ADDENDUM NO. 1 TO THE
SPECIFICATIONS
AND
CONTRACT DOCUMENTS
FOR THE
TOWANDA MUNICIPAL AUTHORITY WASTEWATER TREATMENT
PLANT UPGRADES
PROJECT NO. 22-6006
TOWANDA MUNICIPAL AUTHORITY
TOWANDA BOROUGH, BRADFORD COUNTY, PENNSYLVANIA

ADDENDUM NO. 1

TOWANDA MUNICIPAL AUTHORITY WASTEWATER TREATMENT PLANT UPGRADES APRIL 4, 2025

GROUND LEVEL PROCESS
FLOOR PLANS

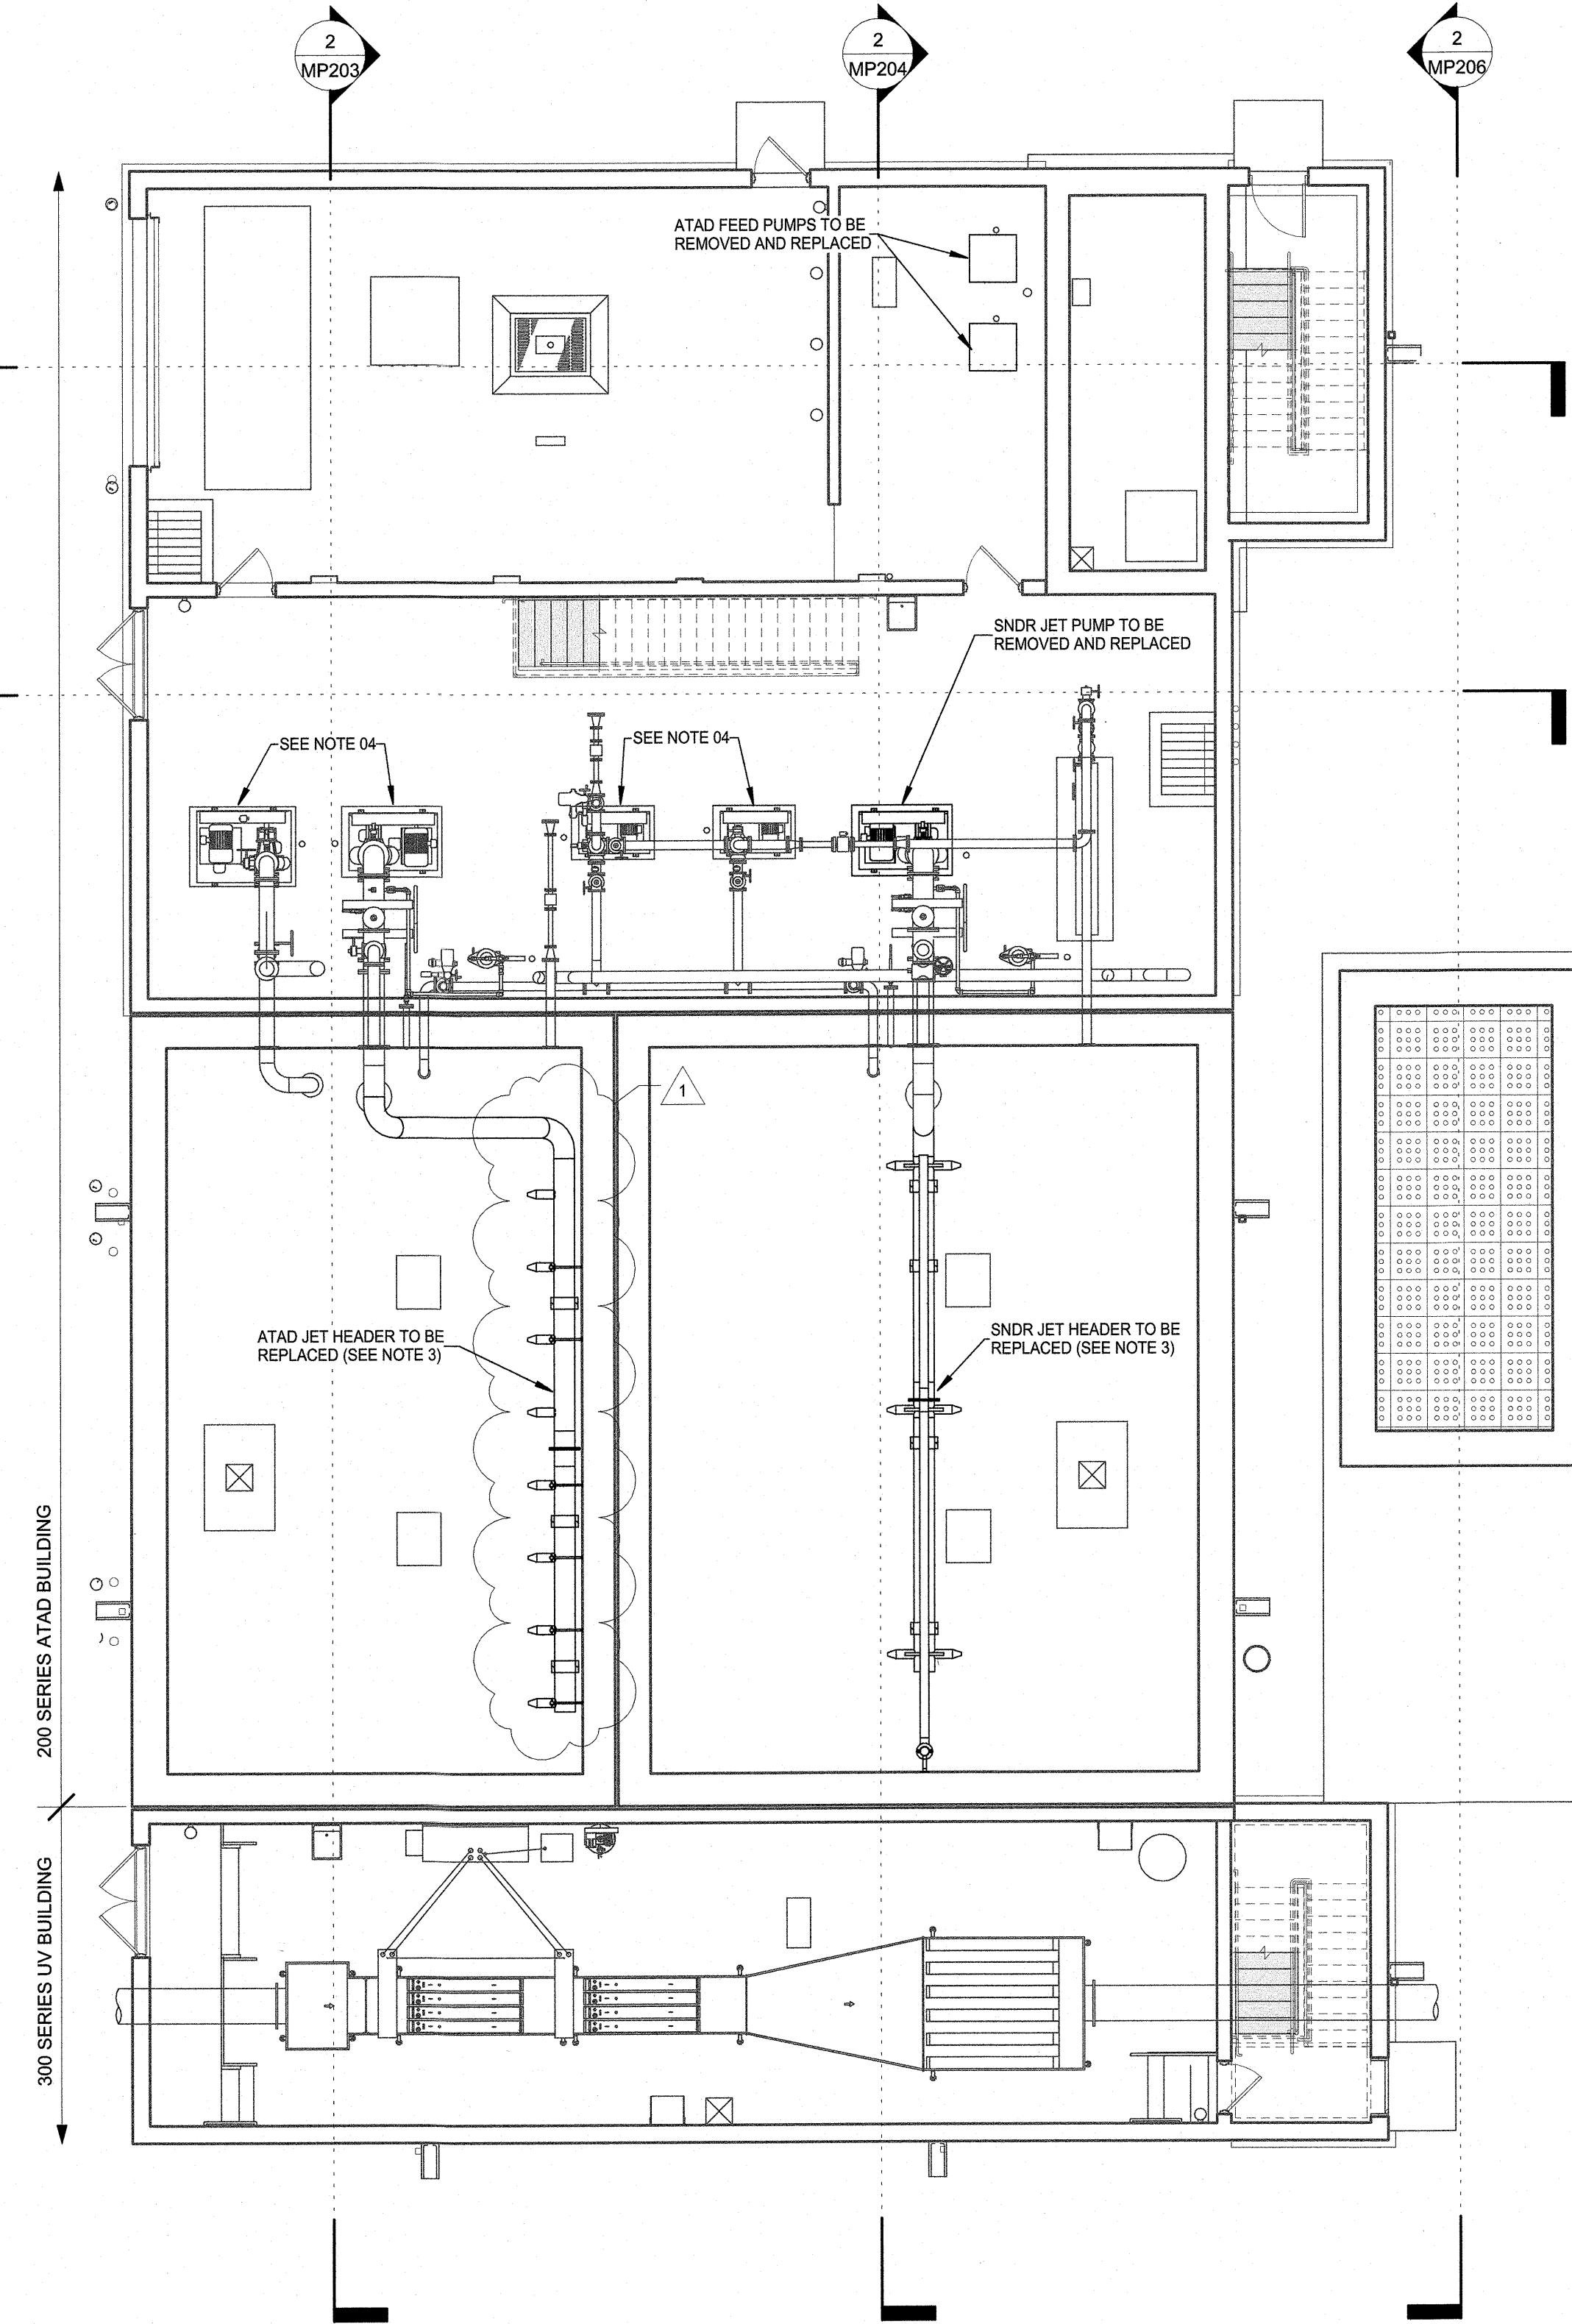
1. Plan Sheet MP201

A revised copy of this plan sheet has been attached to this addendum. The plan sheet now depicts the configuration of the ATAD jet header in a manner which is consistent with the revised Specification Section 467322.

MP202

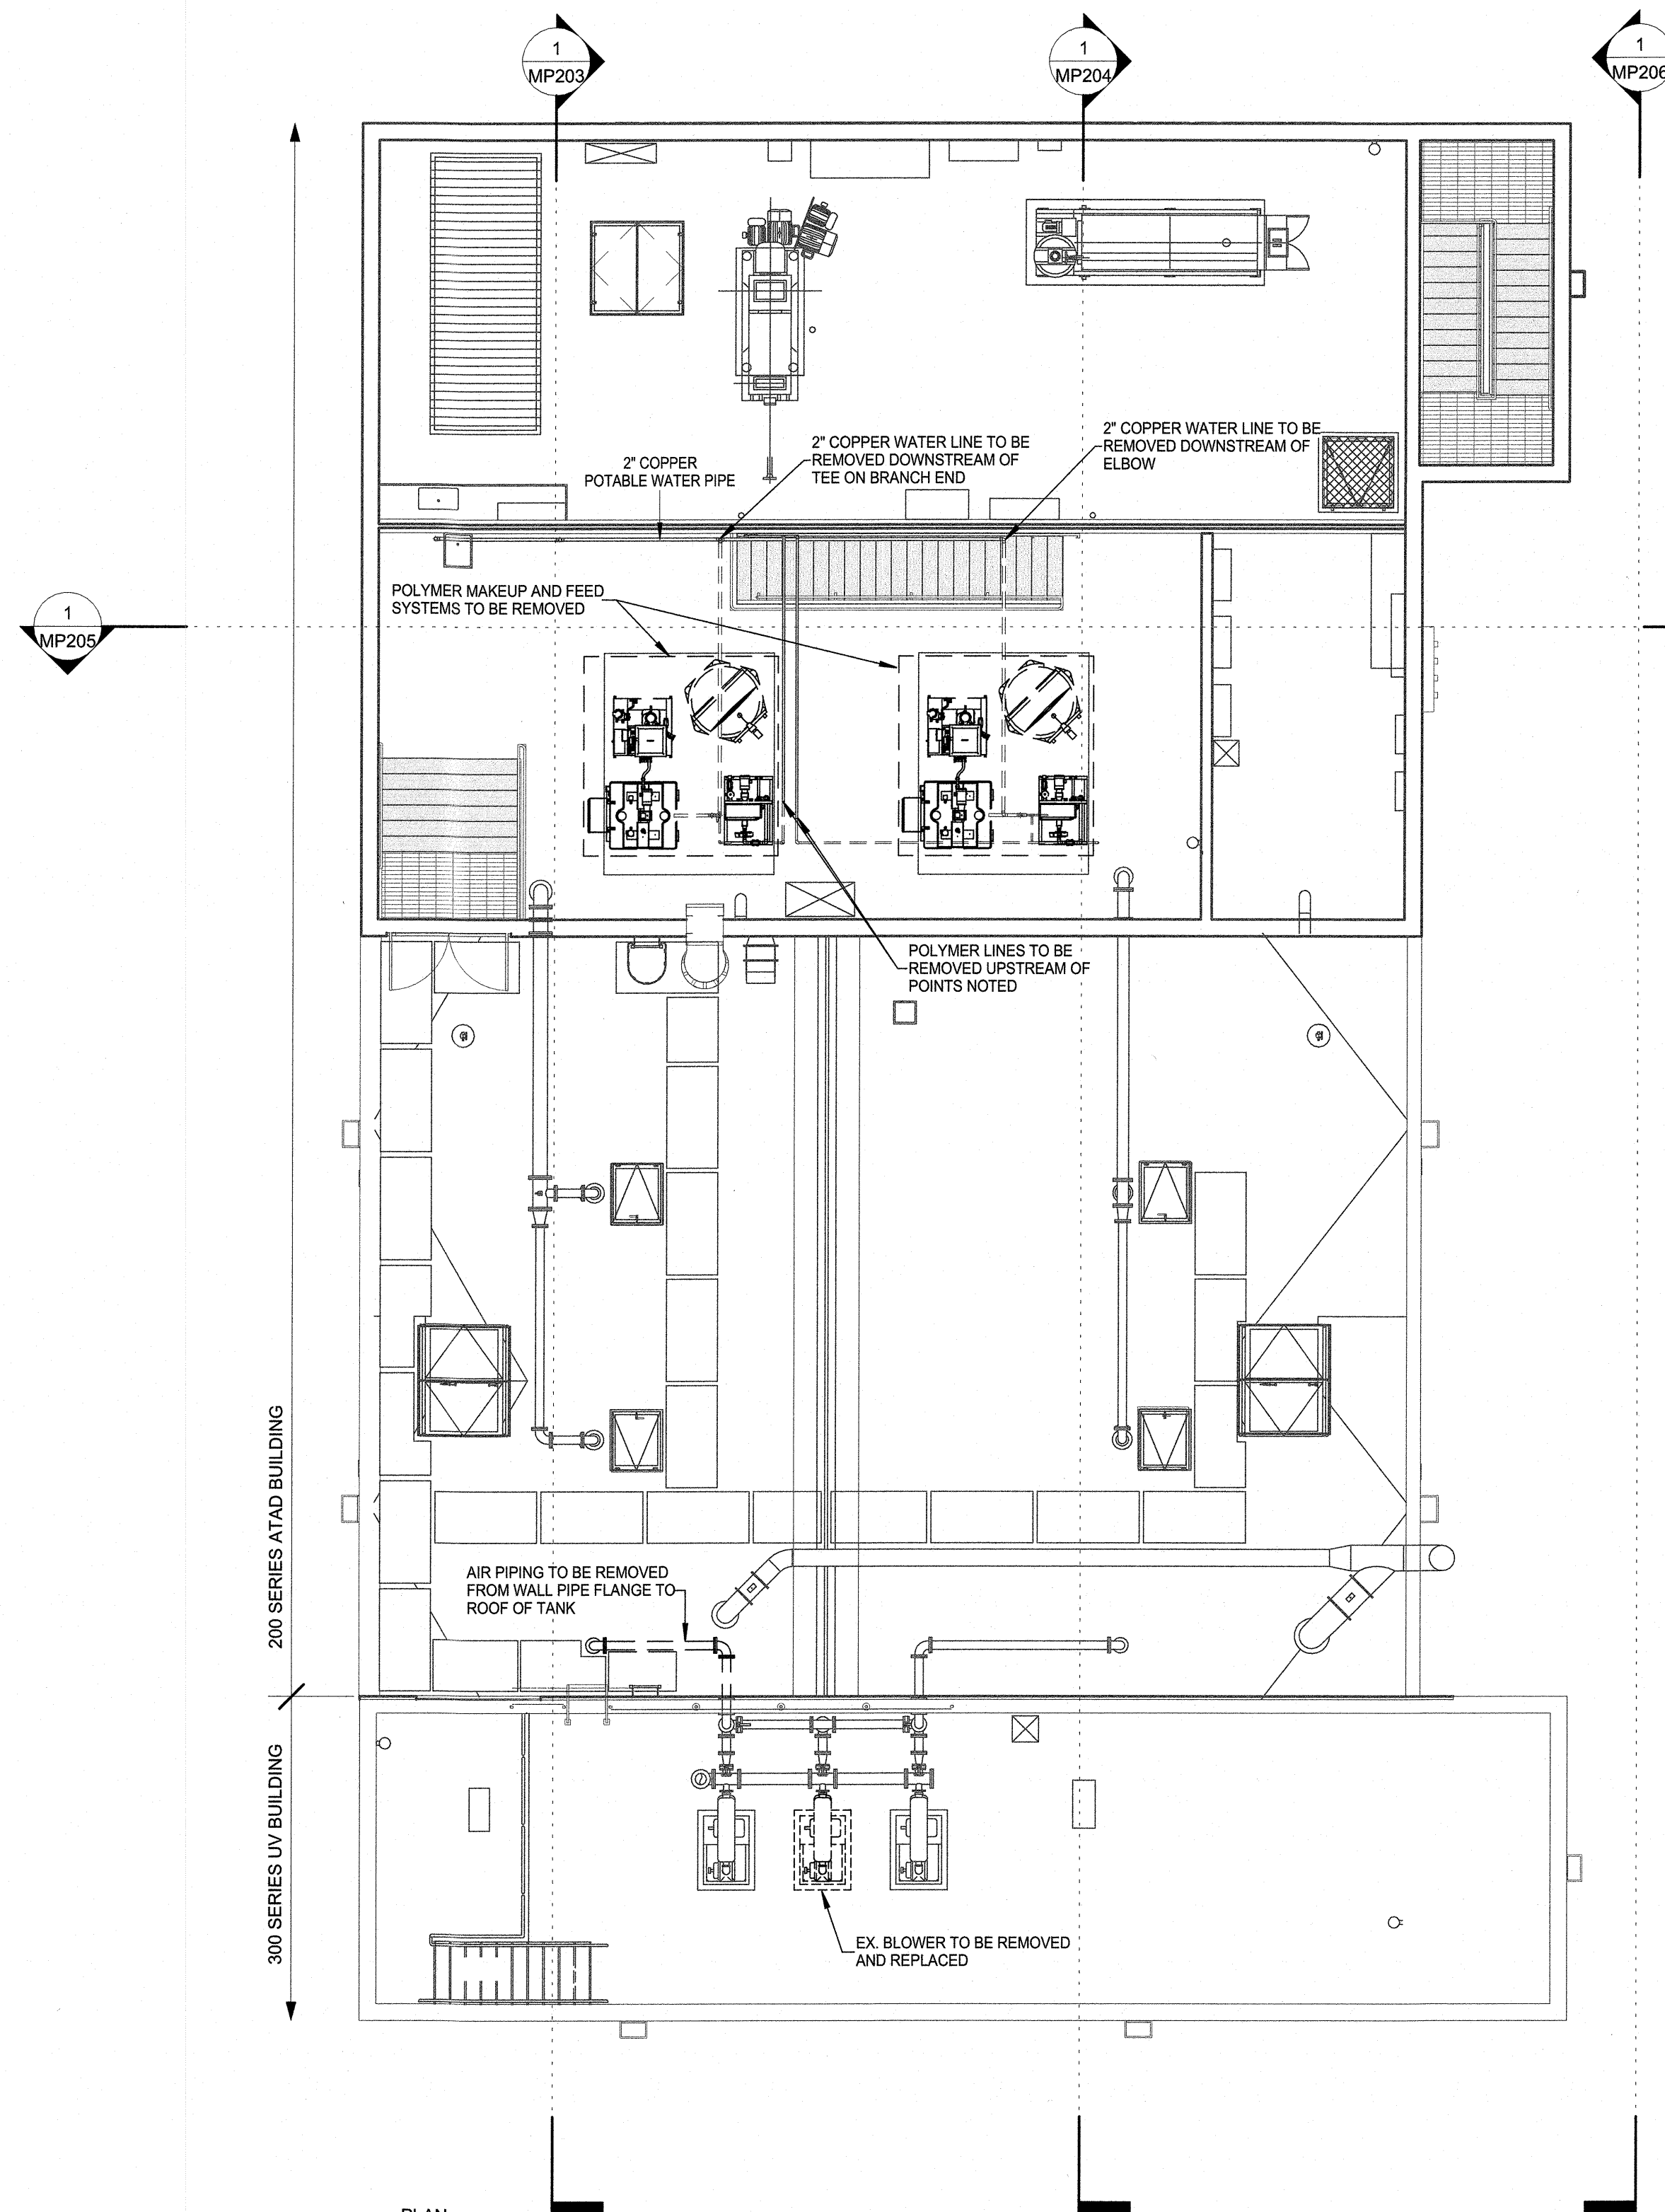
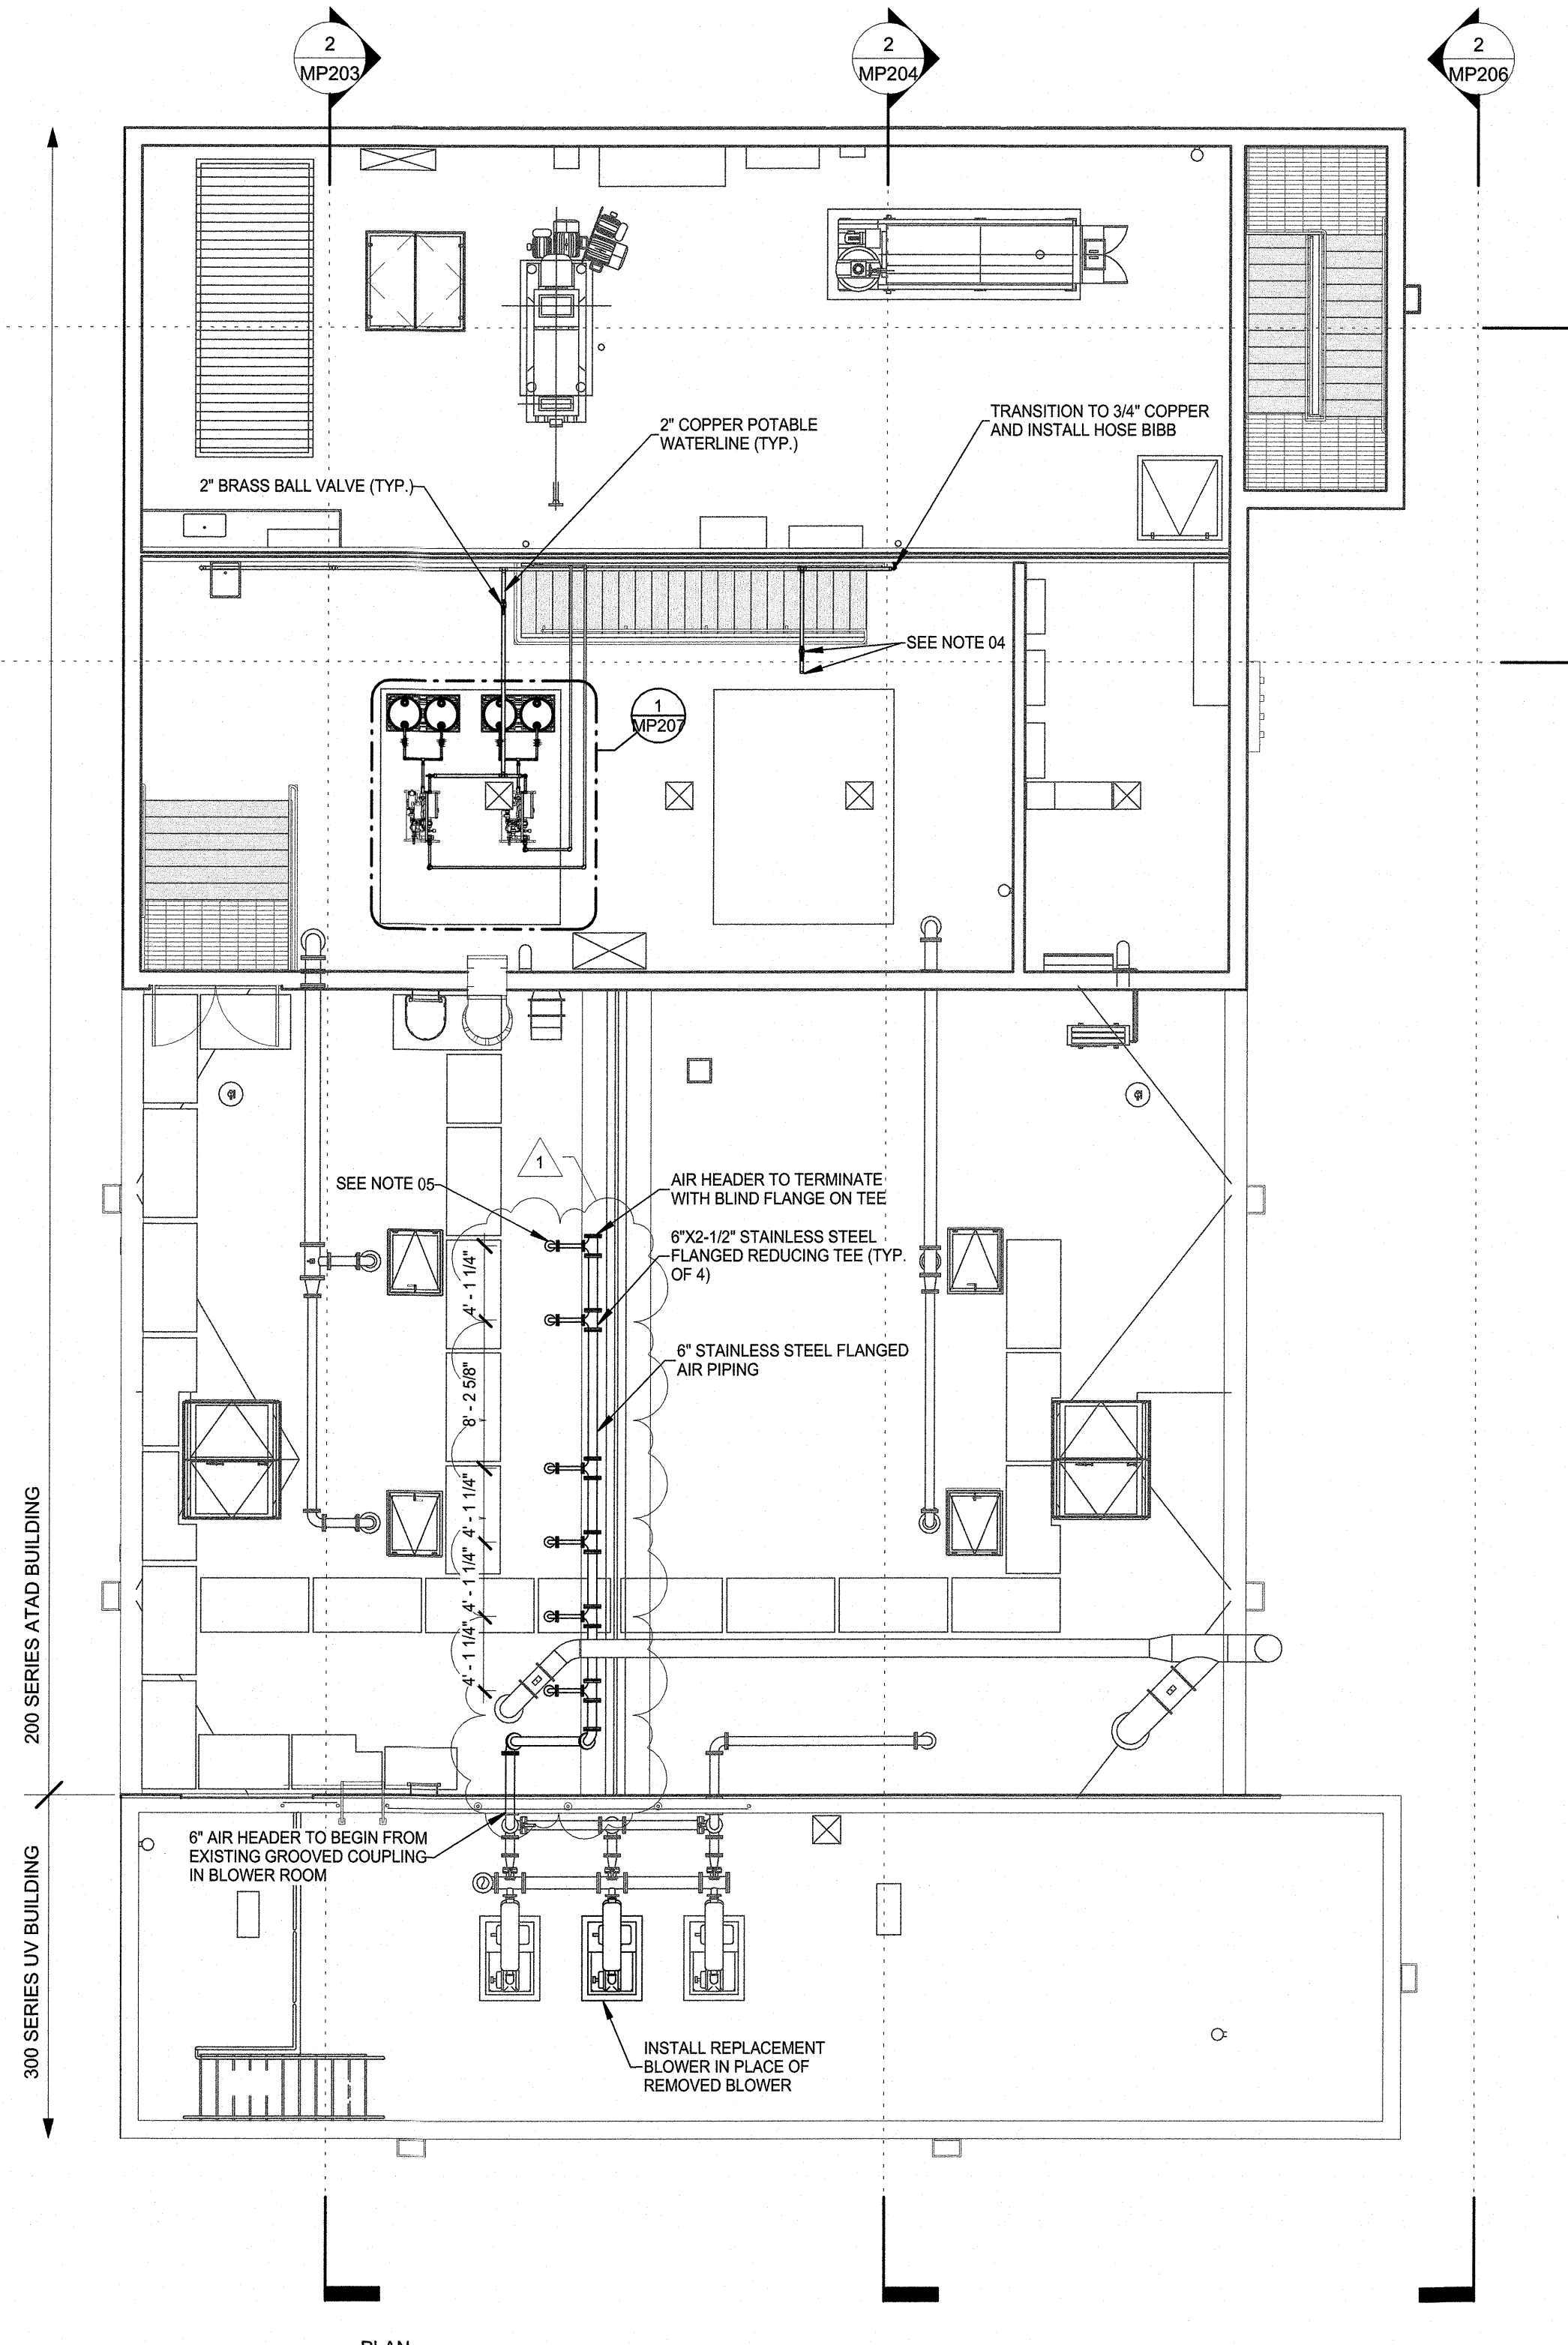
2. Plan Sheet MP202

A revised copy of this plan sheet has been attached to this addendum. The plan sheet now depicts the configuration of the air piping above the ATAD tank in a manner which is consistent with the revised Specification Section 467322.
